Re: **SITE PLAN - DRB #2026-02**
55 THOMPSON DRIVE, ESSEX, VT

At its meeting held on January 15, 2026, the Development Review Board (DRB) voted to approve your site plan for a commercial warehouse and associated parking at 55 Thompson Drive, Essex. The approval is granted with the following Findings and Conditions:

Figure 1: Locations of easements proposed by staff in lines 239-262 above are shown on the Plat filed in 1991 as Slide #258 in the Town of Essex Land Records.

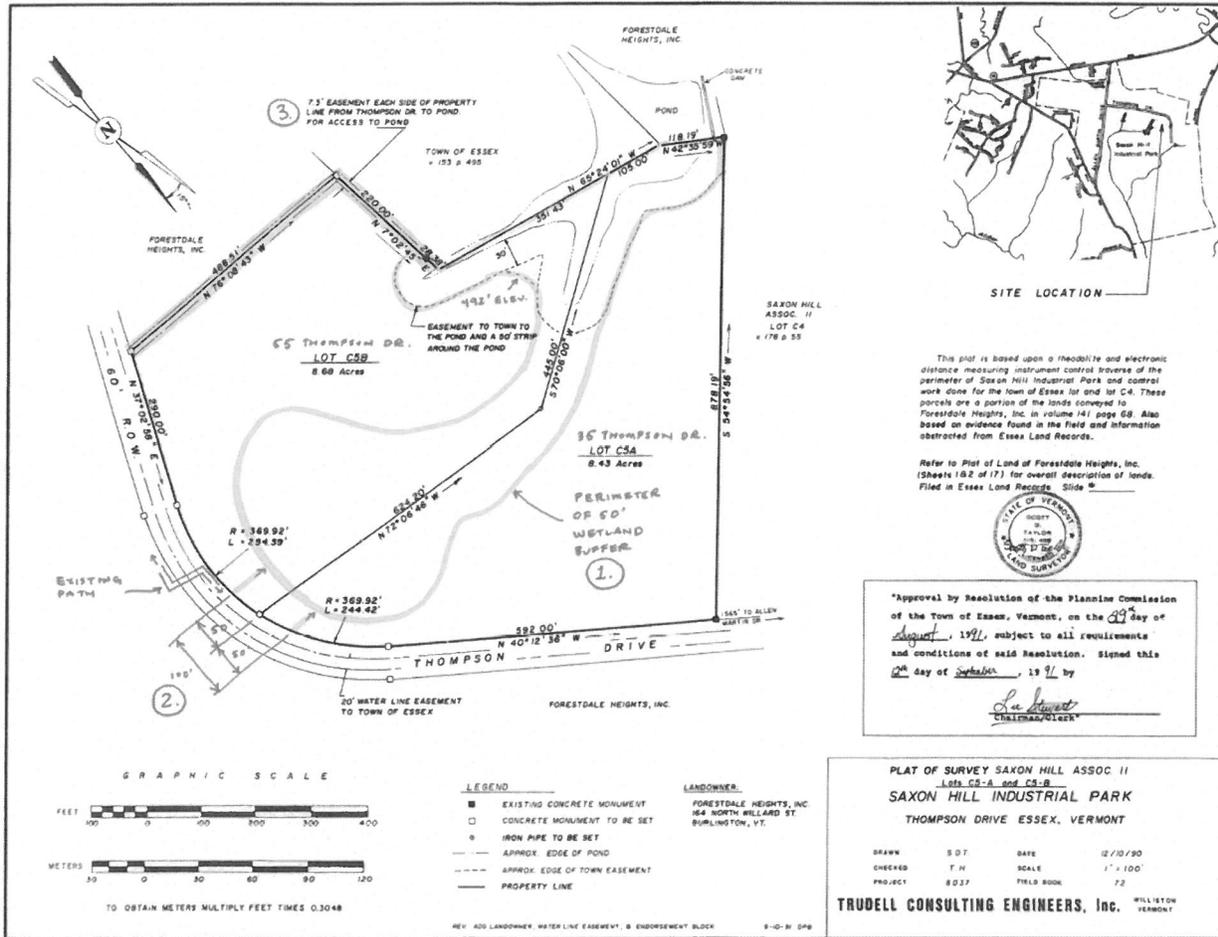
Option 1:

Town staff from Community Development and Parks & Recreation propose the following for the DRB's consideration, and subsequent attorney review:

The easement to the Town is for the purpose of pedestrian and non-motorized (legal e-bikes allowed) ingress and egress for recreational and conservation purposes, together with the right to construct, maintain, repair and improve trail segments and erect and maintain signs. The land composing the easement is recommended to consist of three elements (and see Figure 1 below):

- a. The contiguous area within the outside perimeter of the 50-foot wetland buffer shown in the most recent State of Vermont Agency of Natural Resources' (ANR) data around the pond and proximate wetlands along the west and north sides of 55 Thompson Drive and along the south side of 35 Thompson Drive. This boundary may be re-delineated by ANR in the future as requested by owners of either parcel or by the Town. To facilitate a feasible trail alignment and minimize environmental impacts, the outside perimeter of the easement area is recommended to follow the 492' elevation contour line in the northwest corner of the 55 Thompson Drive parcel.*

- b. When the above contiguous area fails to provide at least 50 feet of Thompson Drive frontage on both parcels, the following shall be in effect: An easement 100 feet wide equally straddling the two parcels to span the gap that may exist between the Thompson Drive right-of-way and the wetland buffer to the west. Within this 100-foot width, a 15-foot-wide floating trail easement is proposed. Land within the 100-foot easement and outside of the 15-foot floating easement is recommended to be conserved for the purposes of a wildlife corridor.*

- c. As illustrated on the plat for lots C5-A and C5-B, a 15-foot-wide strip of land straddling the southern and western property lines of 55 Thompson Drive so as to provide access from the Thompson Drive right-of-way to the pond.*

Figure 2: The Applicant's easement proposal.

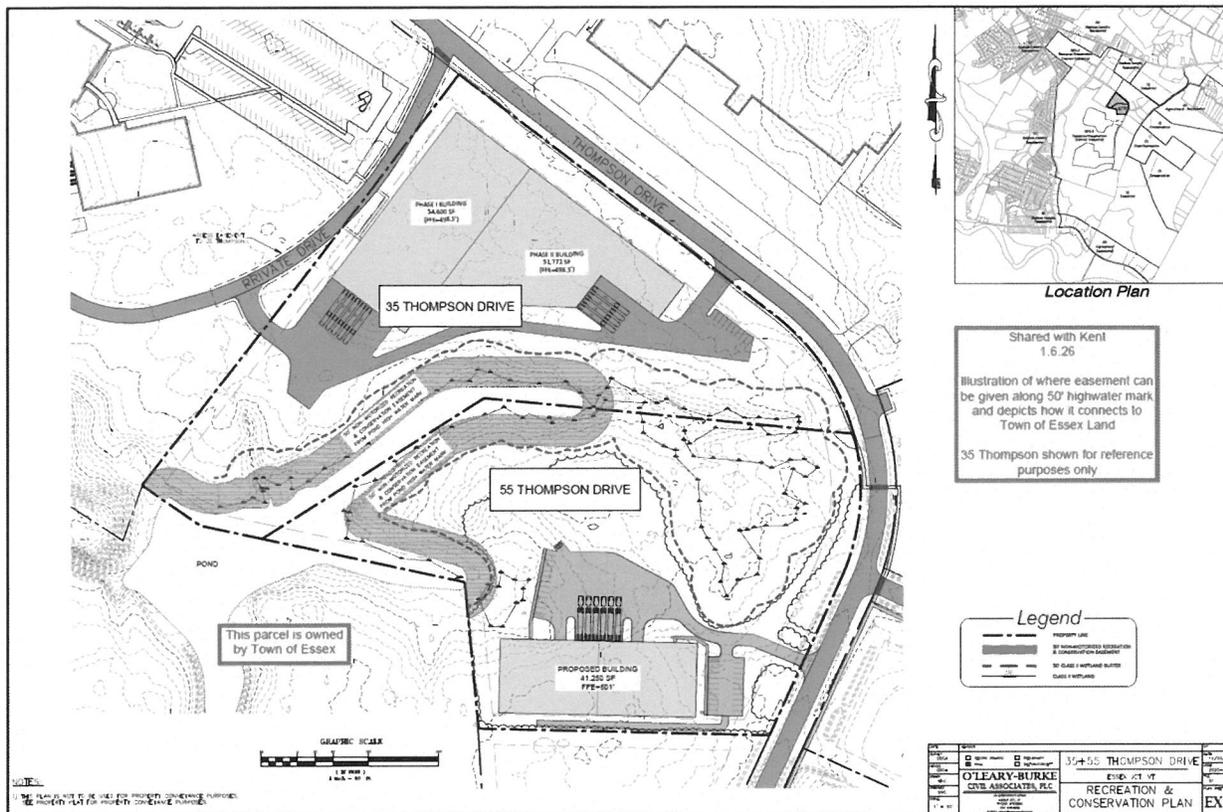
Option 2:

The Applicant proposes an easement area that extends to 50 feet beyond the high-water mark along the sections of the pond that border 35 and 55 Thompson Drive. This area aligns with approvals from 1991 that were never properly filed. However, this proposal does not include the 15-foot-wide easement along the south and west edges of the 55 Thompson Drive parcel. See Figure 2 below.

-Ultimately, we are requesting additional clarification for the location of the proposed easement, including entry and exit points. It would be helpful to see on the map a shaded area that represents that the developer is proposing.

Staff recommend that the DRB indicate their preferred easement concept. This concept should then be reviewed by the Town's attorney to craft the appropriate language. Separate language will be needed for 35 Thompson Drive and 55 Thompson Drive.

Figure 2: The Applicant's easement proposal.

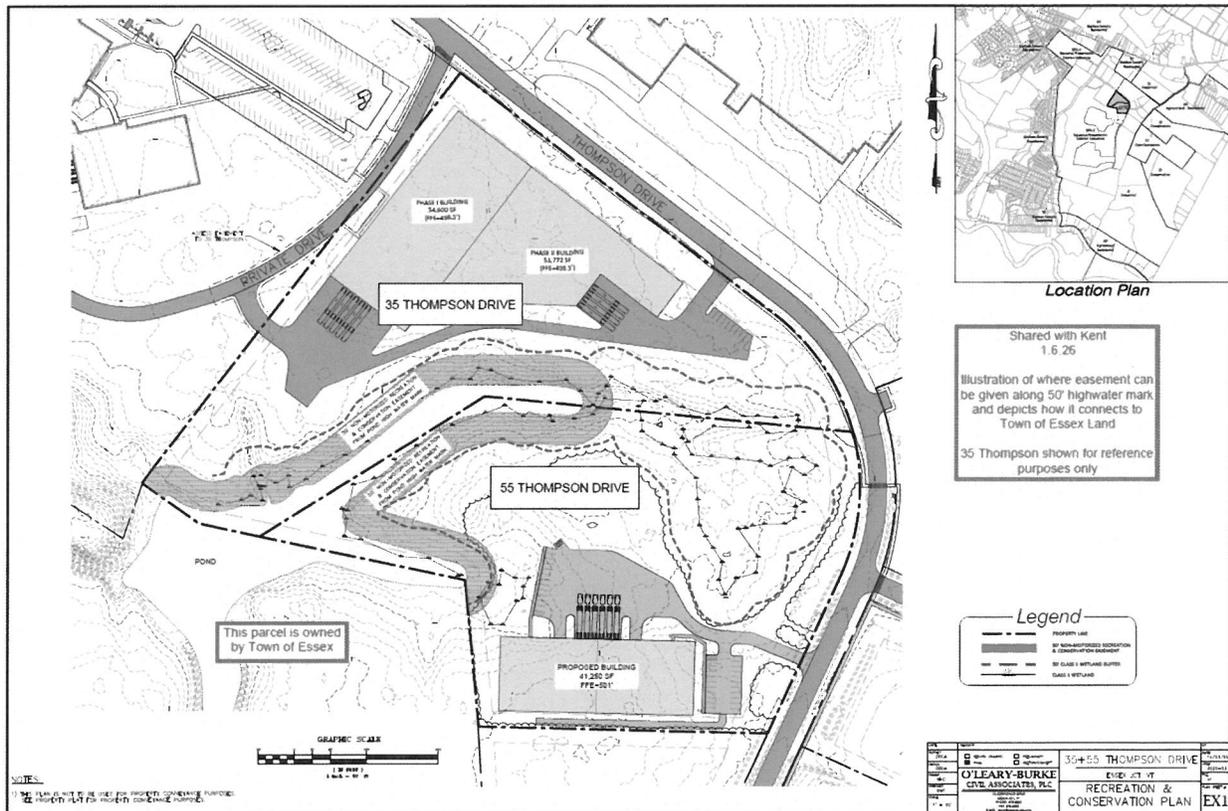
The DRB has determined that the following easement concept should be codified:

Option 2:

The Applicant proposes an easement area that extends to 50 feet beyond the high-water mark along the sections of the pond that border 35 and 55 Thompson Drive. This area aligns with approvals from 1991 that were never properly filed. However, this proposal does not include the 15-foot-wide easement along the south and west edges of the 55 Thompson Drive parcel. See Figure 2 below.

1. All construction shall be in conformance with the plans listed above as may be amended herein.
2. Prior to issuance of a zoning permit, the Applicant shall work with the Town to resolve easement issues in accordance with the DRB’s Findings in item 4 above, which call for an easement area that extends to 50 feet beyond the high-water mark along the sections of the pond that border 35 and 55 Thompson Drive for the purpose of pedestrian and non-motorized (legal e-bikes allowed) ingress and egress for recreational and conservation purposes, together with the right to construct, maintain, repair and improve trail segments and erect and maintain signs.
